GWWO, INC./ARCHITECTS
800 WYMAN PARK DRIVE, SUITE 300
BALTIMORE, MARYLAND 21211
410-332-1009

GWWO PROJECT NO. 17039

ADDENDUM 1

**Rockburn Elementary
School Systemic
Renovation**
Howard County Public Schools

TYPICAL ROOF CURB FLASHING

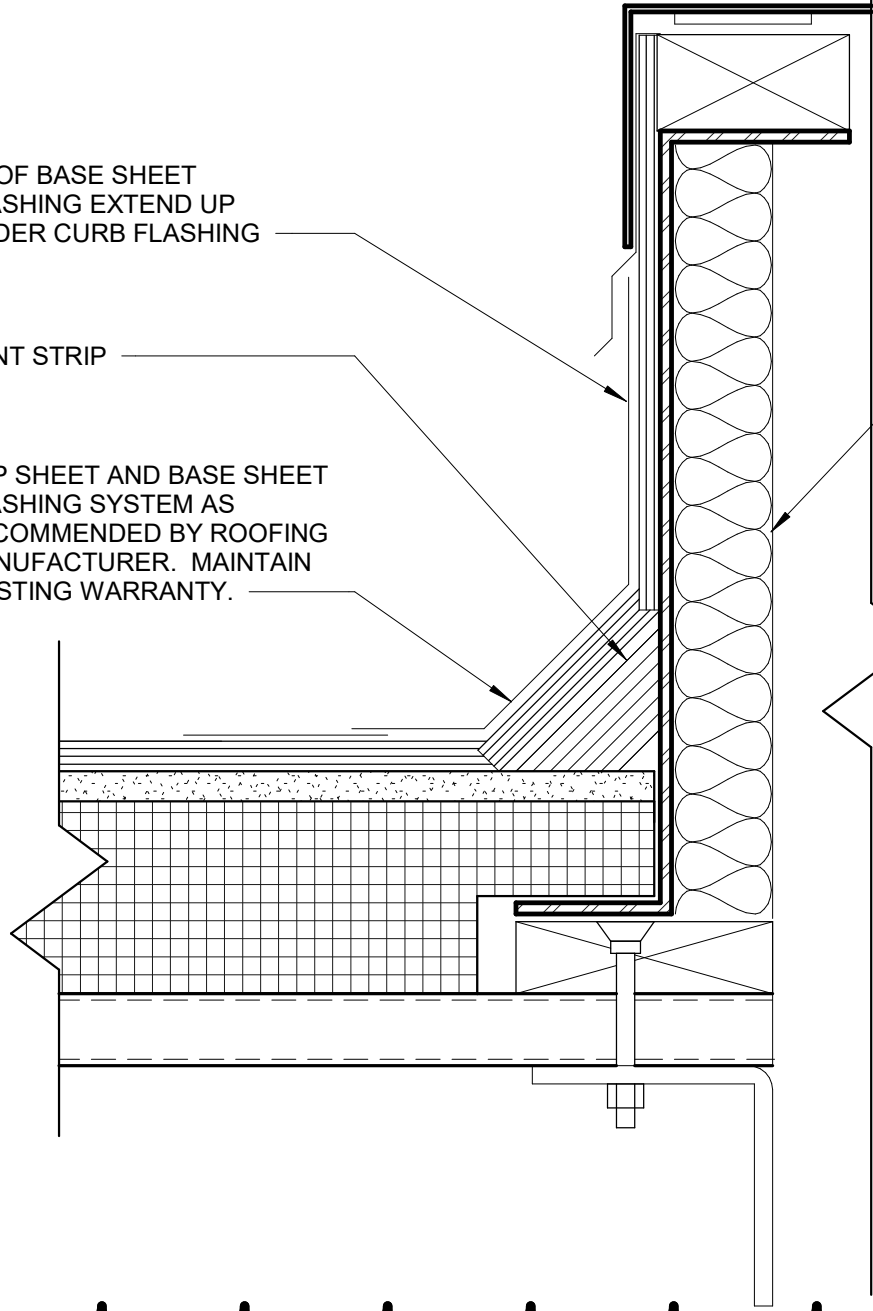
Addendum Item No.	Sheet	Description
AD1.007	AC.1	ADD : Detail as shown in attached sketch SKA.001.
AD1.008	S1.2	REPLACE: Sheet S1.2 with the attached revised sheet S1.2.

ROOF BASE SHEET
FLASHING EXTEND UP
UNDER CURB FLASHING

CAP SHEET AND BASE SHEET
FLASHING SYSTEM AS
RECOMMENDED BY ROOFING
MANUFACTURER. MAINTAIN
EXISTING WARRANTY.

SEE MECHANICAL
DRAWINGS FOR
MECHANICAL
EQUIPMENT CURB.
